IREDELL COUNTY HEALTH DEPARTMENT

IMPROVEMENT PERMIT / AUTHORIZATION TO CONSTRUCT / OPERATION PERMIT / EXISTING SYSTEM INSPECTION

PERMIT# 12857 PIN# 3793-55-4485 DATE 7/2/05

SUBDIVISION AUGUSTA GREENS BLOCK / SECTION I LOT 6 LOT AREA .566 SITE CLASS PS DESIGN FLOW 480 L.T.A.R. .13

AS BUILT SKETCH

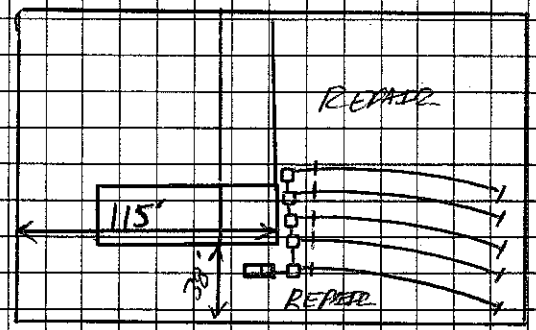
Comments:/Conditions: ① ROAD NOT CUT IN AT TIME OF CHECK. MAINTAIN SETBACKS OR PERMIT WILL BE VOID. ② 1 SPOT WAS 12% SLOPE, LOOSE 5" totaling TB of 19" ON THE SLOW SIDE. DUE TO THIS BE CAREFUL DURING DIGGING.

Comments:/Conditions: ③ LSS SUBMITTED PLAT SHOWING ABANDONED WELL 60' FROM 1ST REPAIR LINE UPSLOPE. Will later submit well abandonment, but well is abandoned. ✱ SETBACK IS MAINTAINED ✱ TO FITTIE FILTER ENCLOSURE

WELL IS 50' OFF REPAIR 2" WELL CASED

④ SYSTEM SLID UP HILL 18' FLIP FLOPPING FIRST TWO LINES OF REPAIR TO THE BOTTOM ↓ TANK MOVED BEHIND THE GARAGE. INSTALLED INFILTRATOR CHAMBERS ↓ ROAD NOT CUT IN AT TIME OF CHECK. MAINTAIN SETBACKS. CONTRACTOR AUTHORIZES CHANGES. ✱

INSTALL SYSTEM ACCORDING TO LSS SPECIFICATIONS SUBMITTED BY MIKE ATKINTES. LSS

Approved 56'x30' PLAN, MAINTAIN SETBACKS 7-12-05
